September 28, 2015

This Addendum to the Invitation for Bids (IFB) serves to notify all interested bidders of clarifications and or changes to IFB No. B15003 General Contractor for Firebaugh Multifamily Apartments, and becomes part of this IFB. Contractors are required to acknowledge receipt of this addendum in their proposal. If not acknowledged, Contractor's proposal may be considered "non-responsive."

# ADDENDUM #2

Project: Firebaugh Gateway Seniors Apartments

**ARCHITECTURAL SITE PLAN**  
SCALE: 1"=10'-0"  
SHEET NO. **A1.02**  
PROJECT NO. 1210

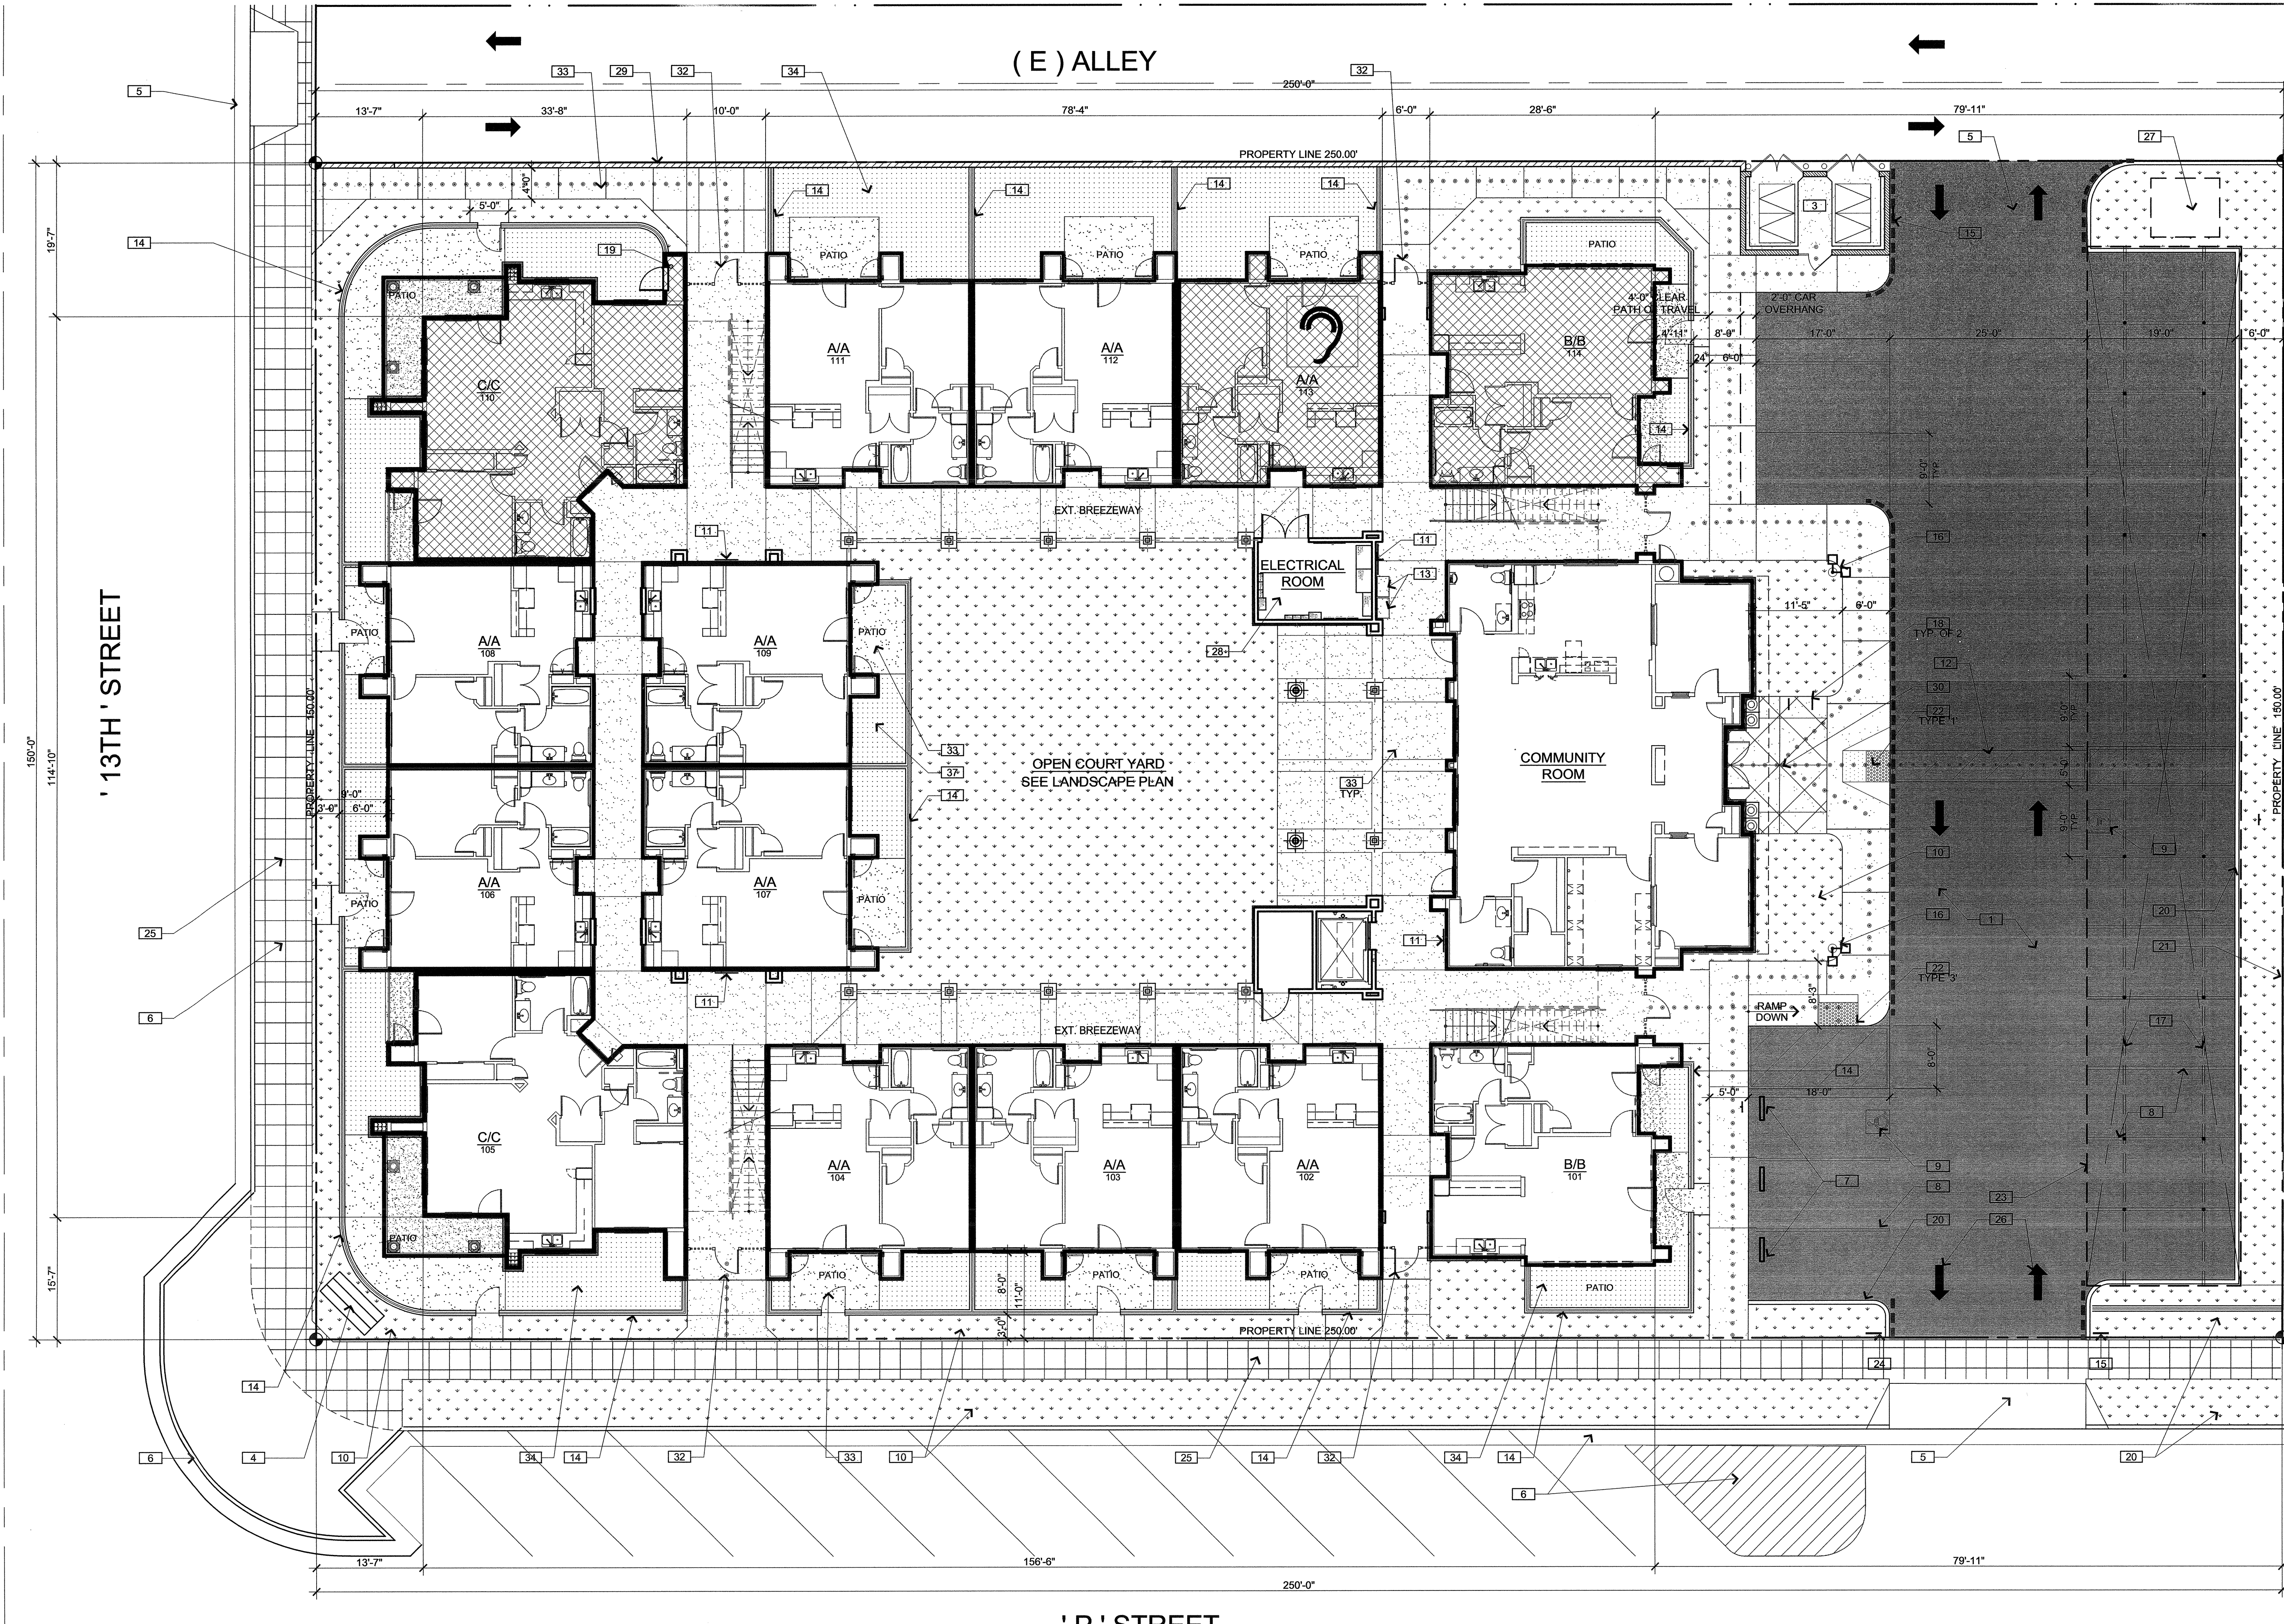
Sheet A1.02: The landscape strip along 13<sup>th</sup> Street has been removed and replaced with concrete to make it a full-width sidewalk. Also, the angled parking striping along 13<sup>th</sup> Street has been removed. (City Engineer Requirements)

Scale:  
1" = 16'-0"  
Date:  
August 11, 2015  
Drawn/Checked:  
NAV / DFM  
Project No.:  
15-1741  
Sheet Number:  
L3.1

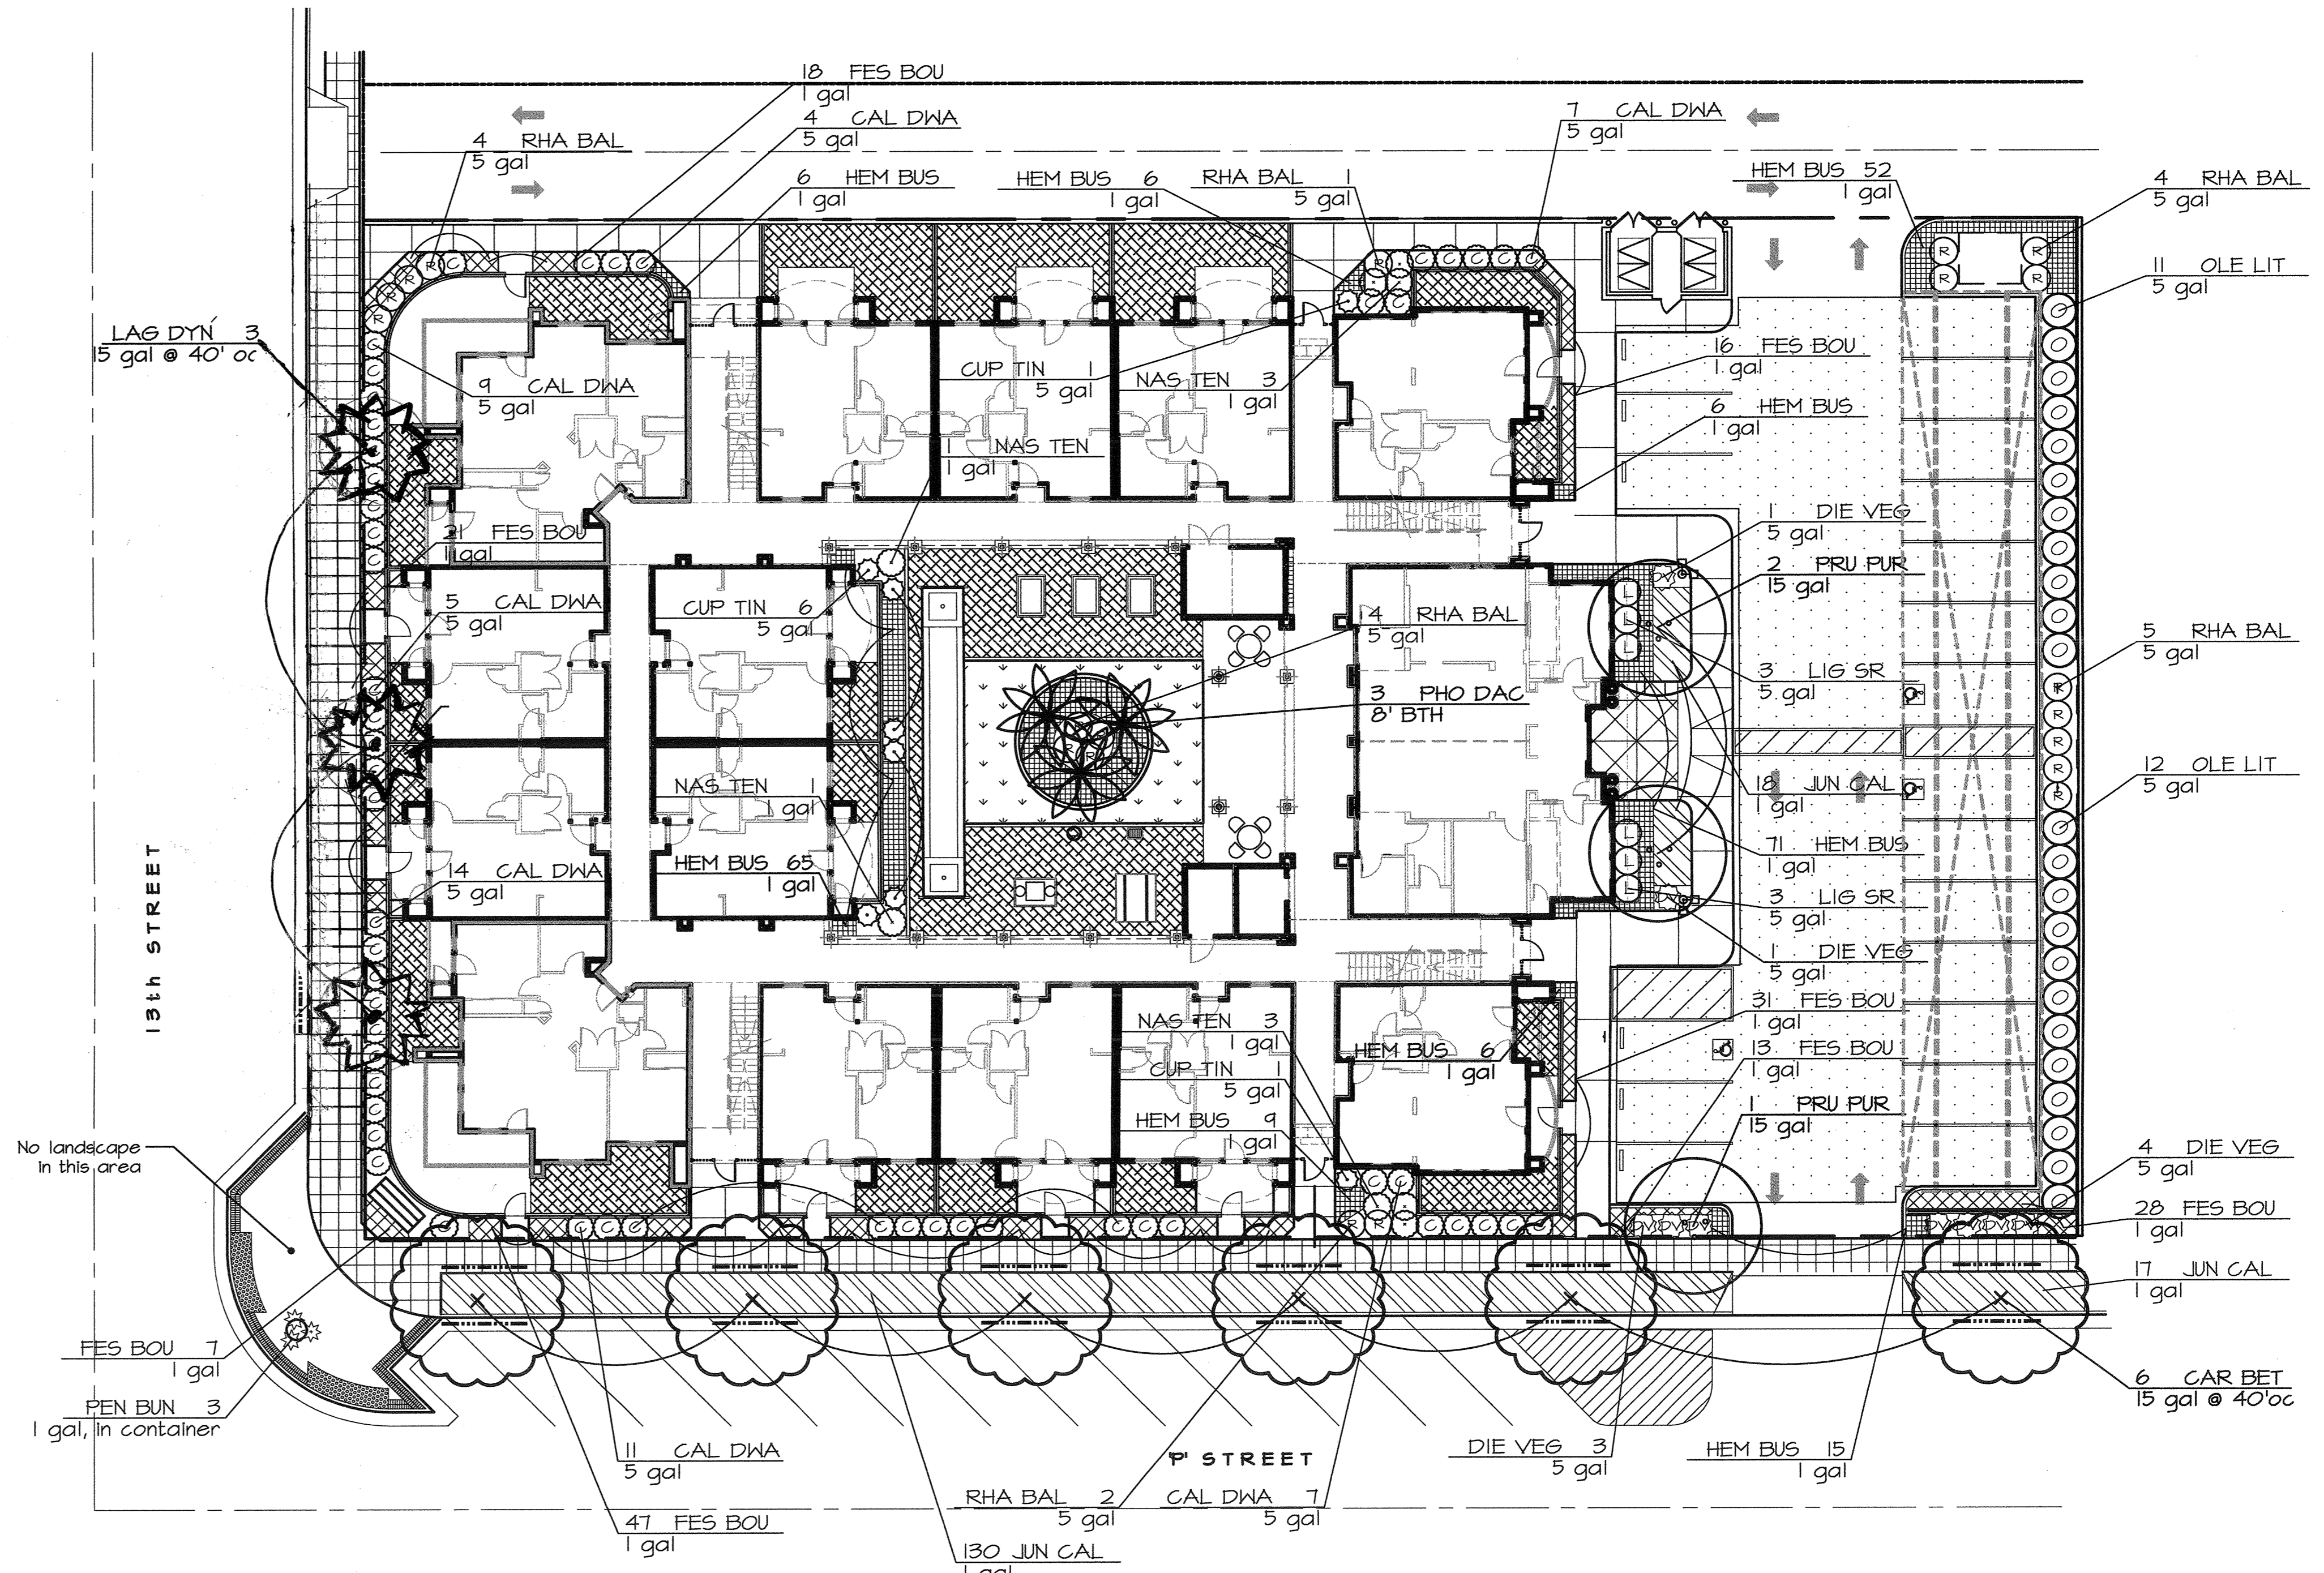
Sheets L2.1 & L3.1: Modified to remove the landscape strip along 13<sup>th</sup> Street and relocate the street trees previously in that landscape strip to be placed behind the property line with the associated irrigation lines and fittings removed or relocated as required.
